Planning Department
Environment and Infrastructure
Council Headquarters
Newton St Boswells
TD6 0SA

Reference: Review of Local Plan for Ednam Village Boundaries and "Potential" sites available for Building

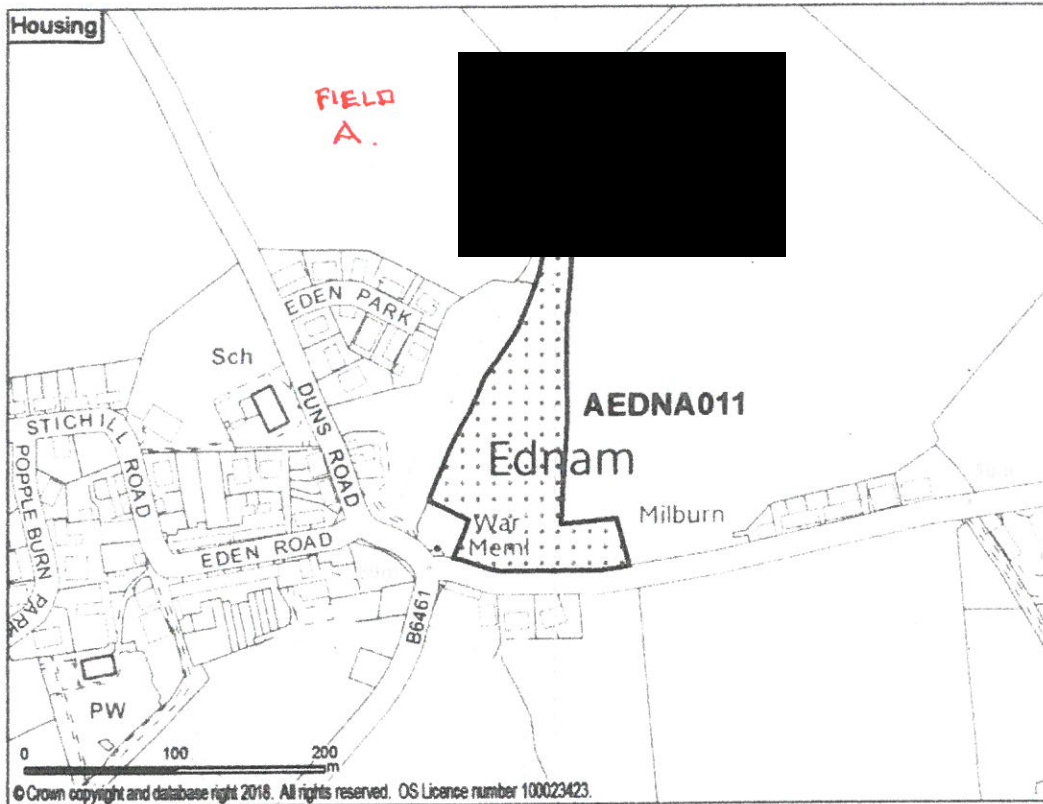
approximately six years ago and today I have noted that this site has been fenced off with the boundaries established as per the profile on the map.

As there has been no obvious change to the infrastructure of the village, can you advise me why this site is now being considered for development when permission was refused by the Planning Department six years ago.

SITE REFERENCE	SITE NAME	SETTLEMENT	SITE SIZE (HA)	SITE CAPACITY	OPTION
AEDNA013	Land North of Primary School	Ednam	1.4	20	Alternative

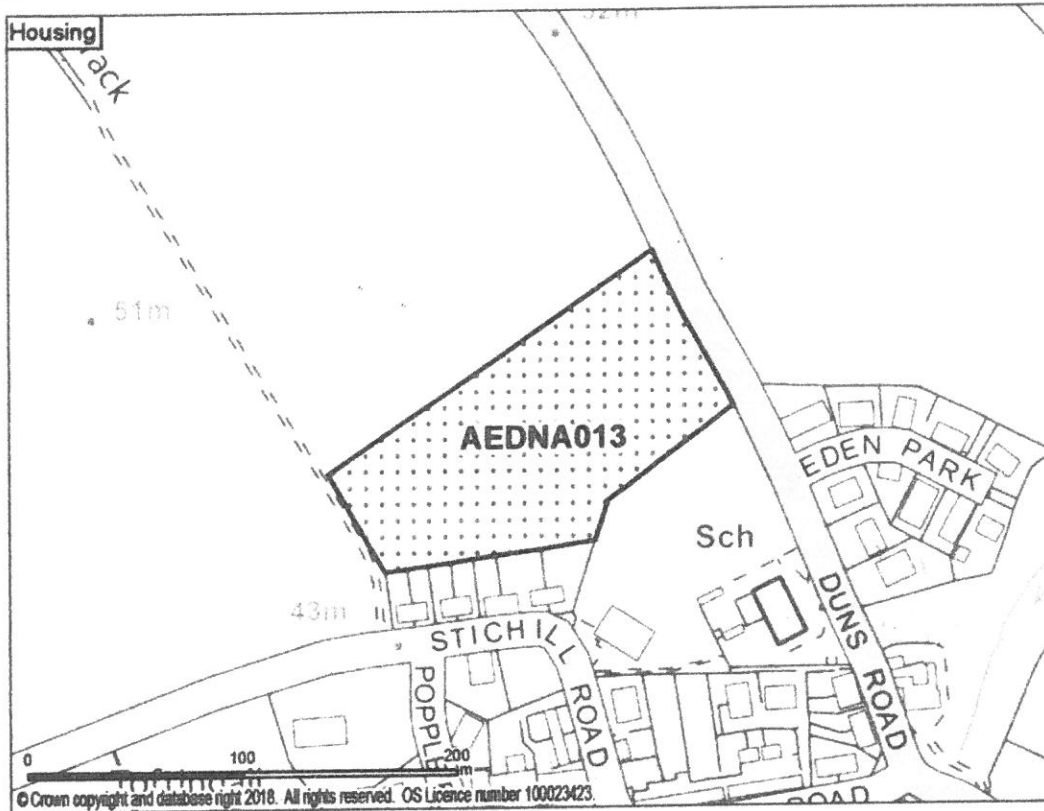
Ref: Site AEDNA 013

Although I consider any further development in the village unjustifiable, due to a lack of services and facilities, I consider this site most suitable of the two sites proposed because of safe access to the school, playing field and village hall.

My only concern is the proposed access onto the B6461. This could be overcome by extending the speed limit zone.
